# IFL FACTORY LIMITED

6<sup>th</sup> May 2018

# Observations

First Floor Layout Plan

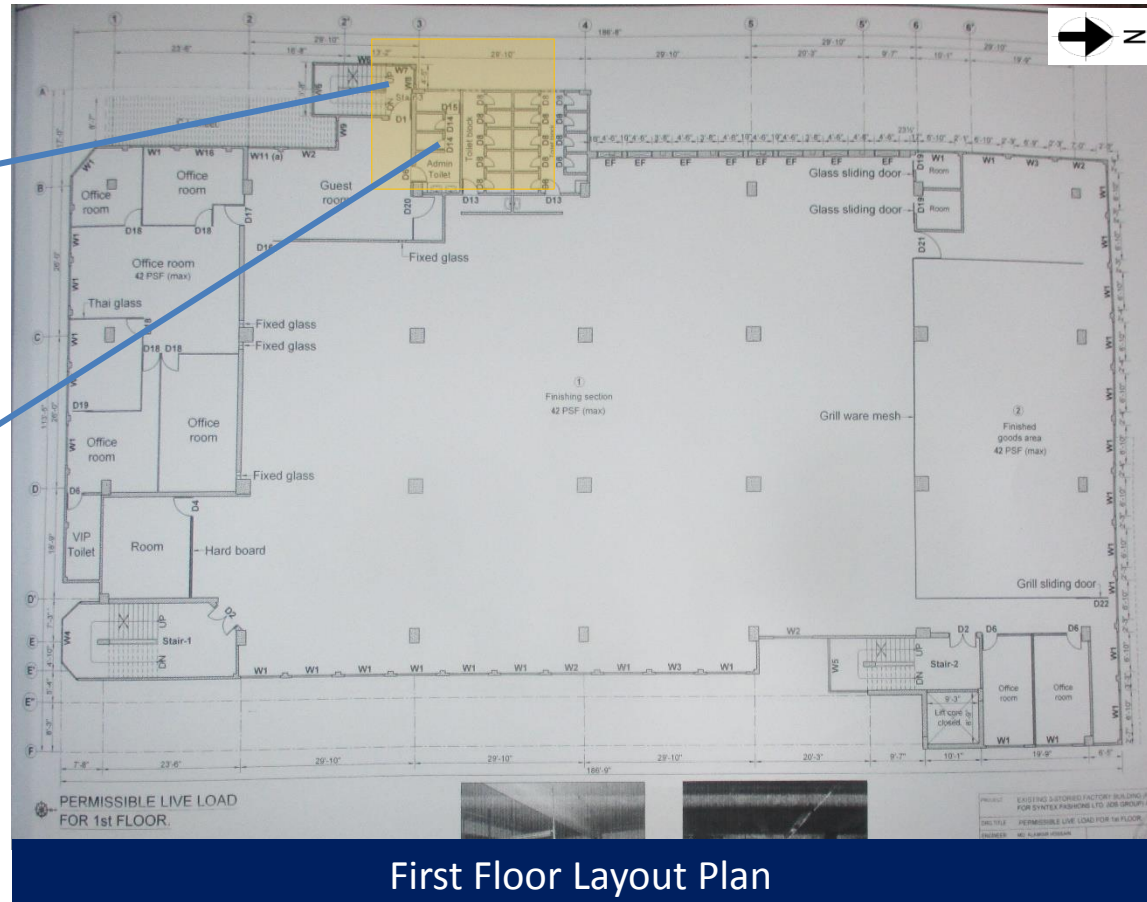
**Column stress exceeds the normal design limits**

Cursory calculations indicate that the working stress of ground floor column & foundation under toilet area exceeds the normal design limits, assuming minimum concrete strength. Building engineer to verify in-situ concrete strength and confirm grade of steel reinforcement used.

| Item No. | Observation                                                                                                      | Recommended Action Plan                                                                                                                                                | Recommended Timeline |
|----------|------------------------------------------------------------------------------------------------------------------|------------------------------------------------------------------------------------------------------------------------------------------------------------------------|----------------------|
| 1        | (Factory building)<br>Column stress exceeds the normal design limits                                             | Factory Engineer to review design, loads and columns & foundation stresses in area identified above.                                                                   | 6-weeks              |
| 2        | (Factory building)<br>Column stress exceeds the normal design limits                                             | Verify in-situ concrete stresses by 100mm dia. cores from min. 4 no. column from ground floor level.                                                                   | 6-weeks              |

Typical Beam layout plan

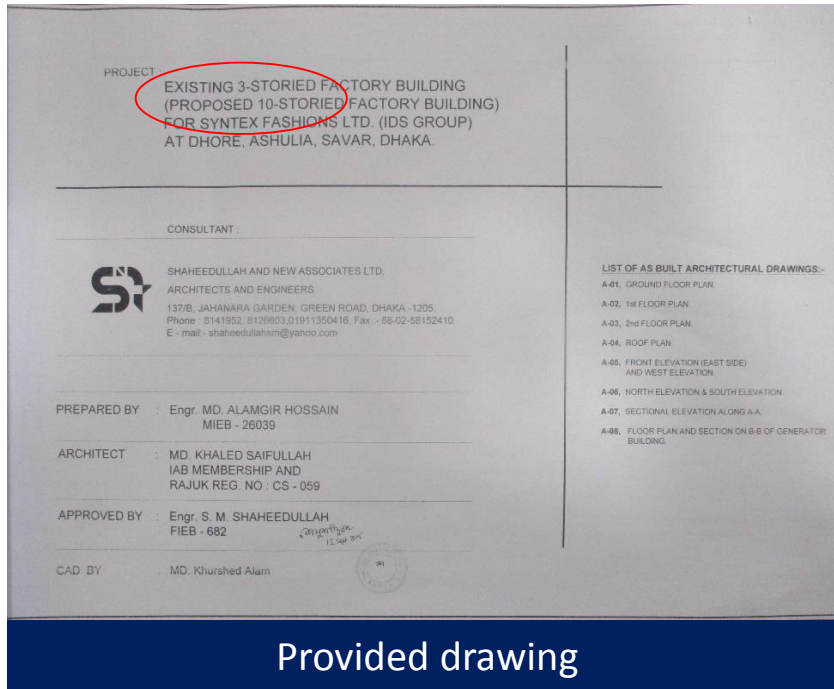
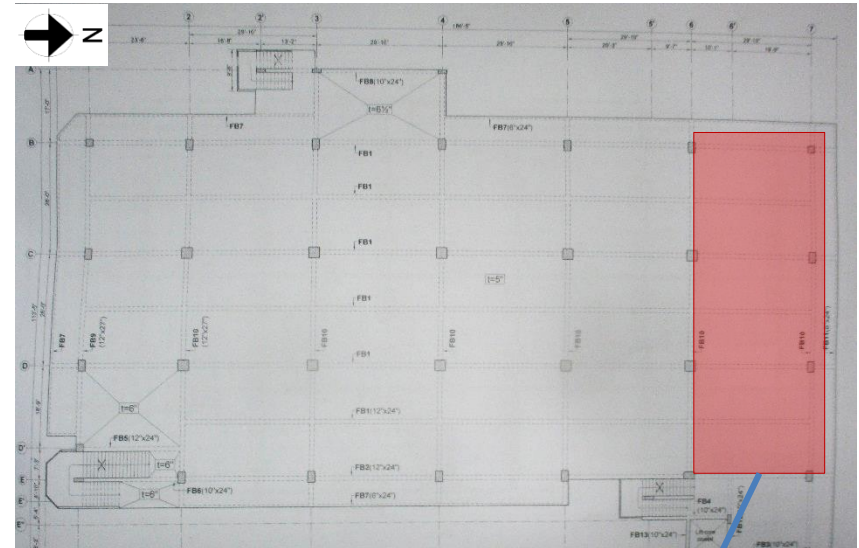
During inspection the building was 6 storied. A set of as-built drawing has been provided for 3 storied factory building which was prepared in 2015. However, factory is required to prepare full set of as-built drawing.

At 5<sup>th</sup> floor steel column & beams are found at North side of the building. No details were found for steel part.

| Item No. | Observation                                                                                                      | Recommended Action Plan                                                                                                                                                | Recommended Timeline |
|----------|------------------------------------------------------------------------------------------------------------------|------------------------------------------------------------------------------------------------------------------------------------------------------------------------|----------------------|
| 6        | (Factory Building & Utility Buildings)<br>Insufficient as-built drawings of factory building & utility buildings | Building Engineer to survey as-built structure and prepare an “as constructed” drawings which reflect the actual site dimensions with complete structural information. | 6-weeks              |

Stagnant water on 5<sup>th</sup> floor

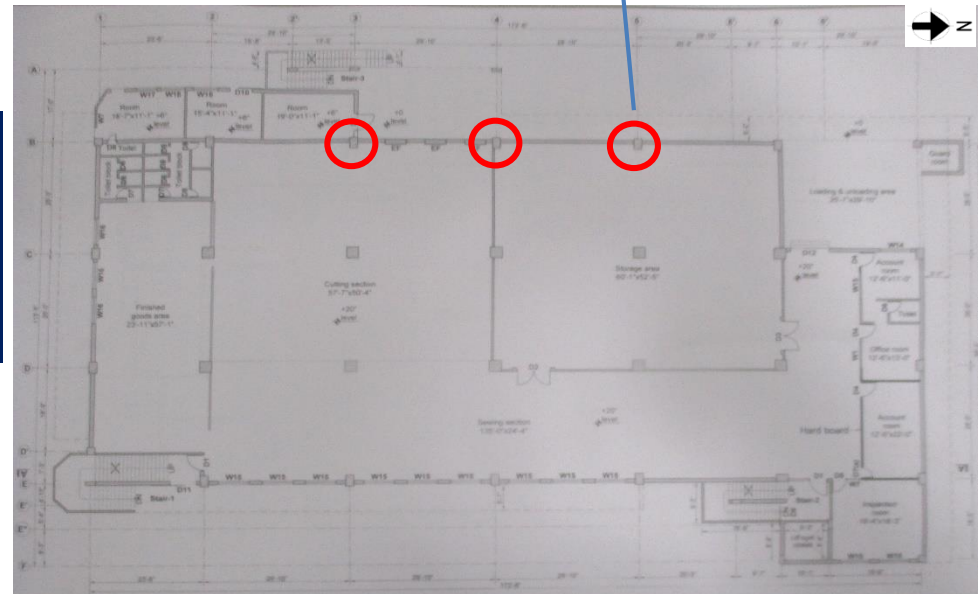
Water ponding was found at 5<sup>th</sup> floor and roof of the factory building. Factory is required to improve water drainage system to avoid water clogging.

| Item No. | Observation                                                                        | Recommended Action Plan                                                                                        | Recommended Timeline |
|----------|------------------------------------------------------------------------------------|----------------------------------------------------------------------------------------------------------------|----------------------|
| 7        | (Factory Building)<br>Water ponding on roof                                        | Factory is required to provide water proofing layer and improve water drainage system to avoid water clogging. | 6-weeks              |
